**From:** [auburnwarren@nalcenergy.com](mailto:auburnwarren@nalcenergy.com)  
**To:** [Todd Williams](#)  
**Subject:** Re: Hardcopy of latest version of the report  
**Date:** Friday, September 9, 2011 11:11:05 AM  
**Attachments:** [.png](#)  
[Nalcor discussion points 11.09.09.docx](#)

**Discussion Draft – for Internal Use Only**

## **Independent Supply Decision Review**

September 9, 2011

**Figure 4: Island Hourly Demand, 2010** Winter Demand is Substantially Higher than Summer (January label is misspelled in this chart)

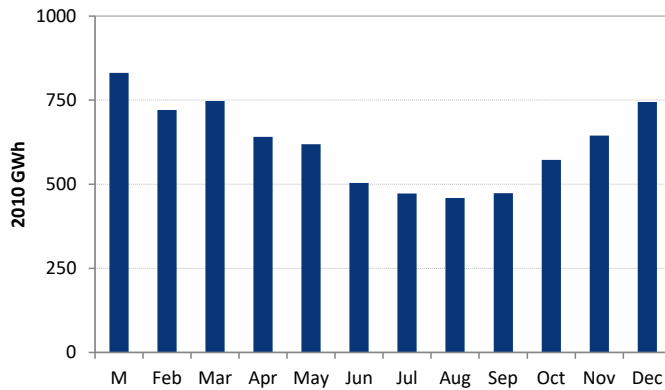
Commented [AW6]: 8760 chart

**Figure 5: Minimum and Maximum Island Peak Daily Demand, 2010** Use is over Twice as High as Lowest Day Use

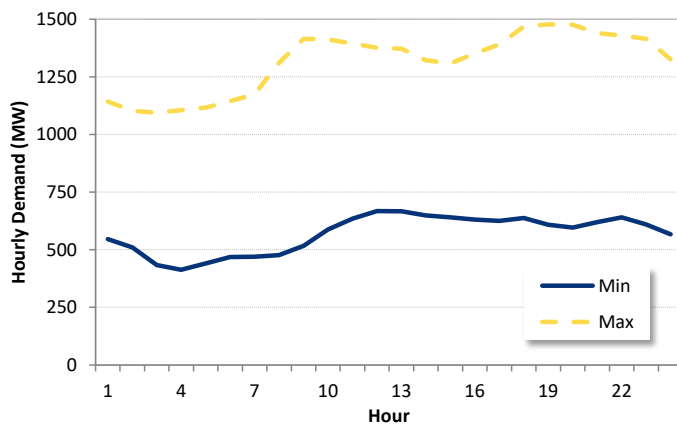
Commented [AW7]: Discuss format

**Figure 6 - Isolated Island Expansion Plan (to be updated)**

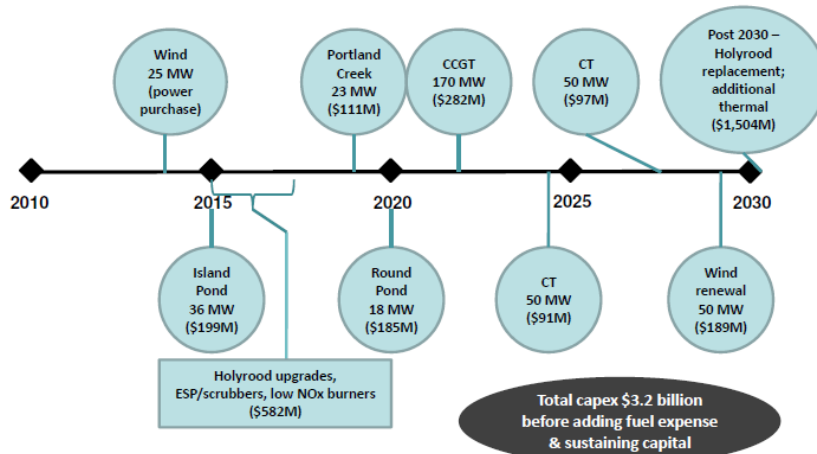
**Commented [AW8]:** Consider updating figure with updated graphic to be provided by Nalcor

**Figure 8: Gateway Process**

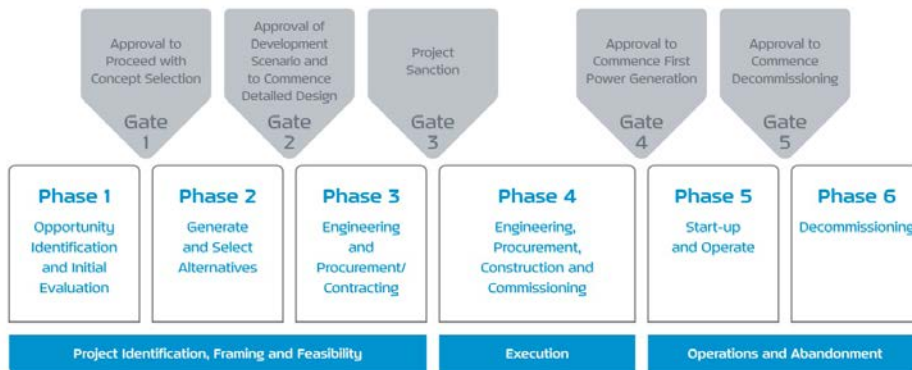
Commented [FS10]: Fix reference.

Figure 9: Wind Map of Canada (mean wind speed 50 m above ground)

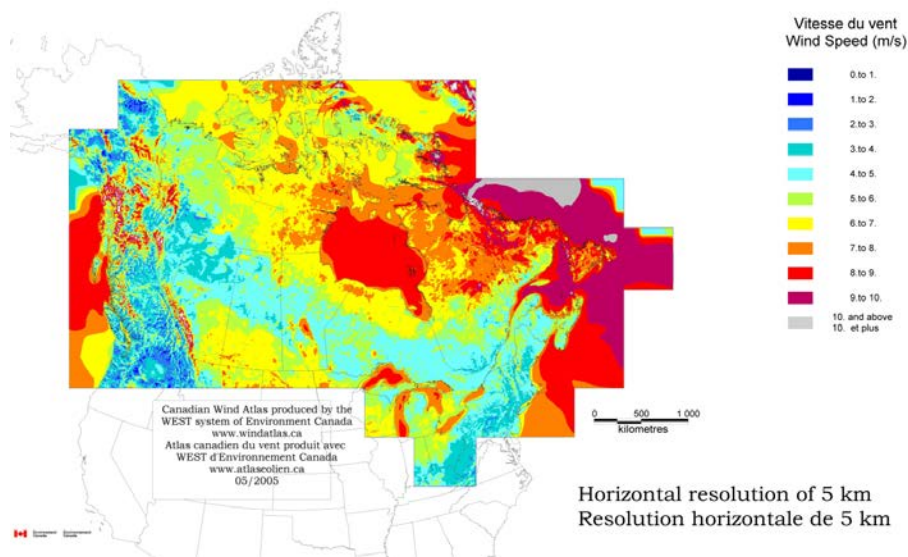
Commented [AW18]: More direct; to discuss further development of this section

**Table 7: Fuel Cost Forecast**

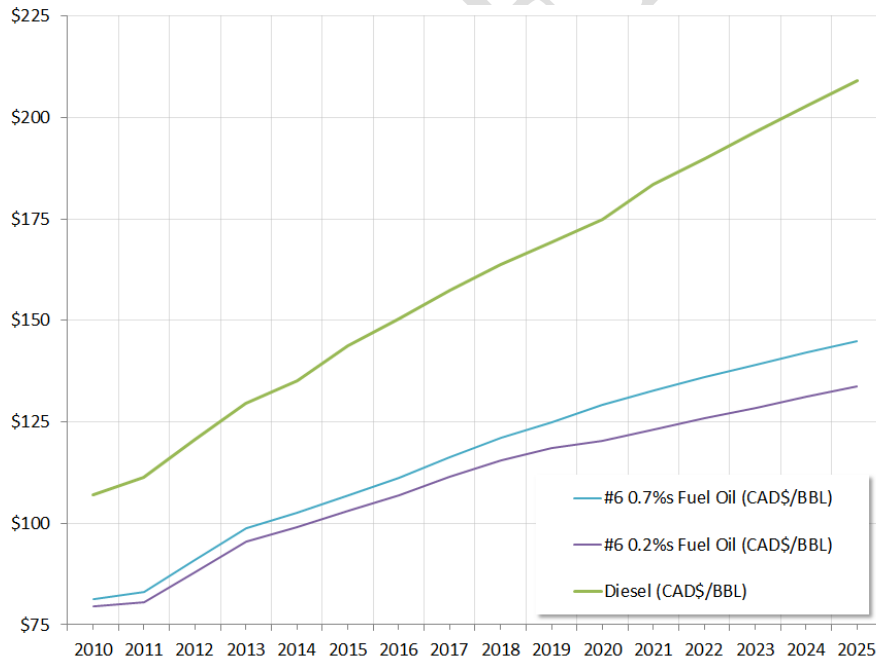
Commented [AW61]: To discuss – Nalcor takes PIRA forecast and applies supplier discounts and foreign currency exchange out to 2025 to derive CAD landed prices. Beyond that prices increase at the rate of CPI. Reference should be made to date forecast was prepared.

Commented [AW62]: To discuss formatting; no requirement to detail beyond 2025 and insertion of source

**Figure 13: Muskrat Falls PPA Projected Volumes**

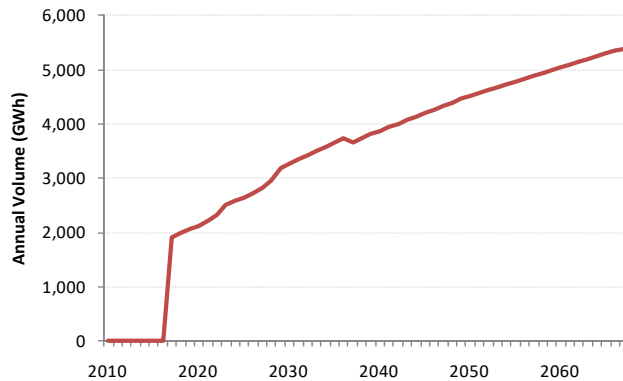
Commented [AW71]: Change title / data to MF data

Commented [AW72]: To correct

**Figure 20: GHG Emissions: Interconnected Island and Isolated Island Cases**

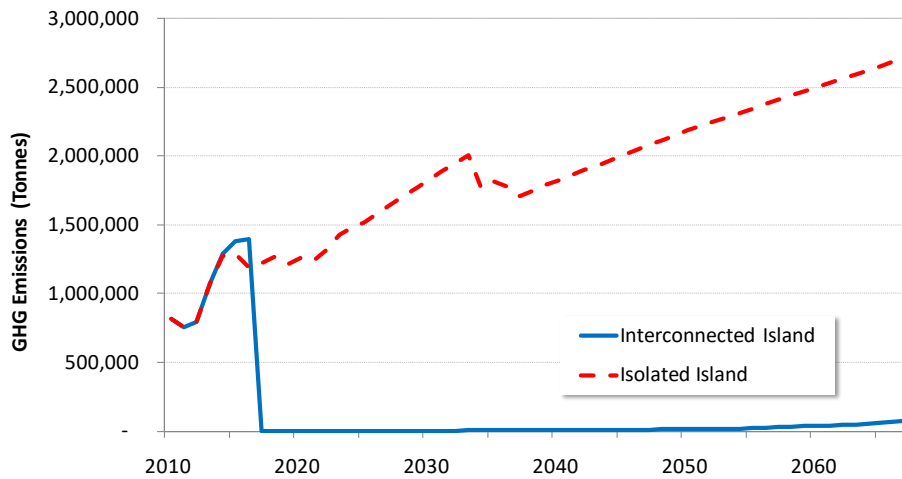
Commented [AW86]: Confirm methodology for post-2025  
Insertion of chart with emissions
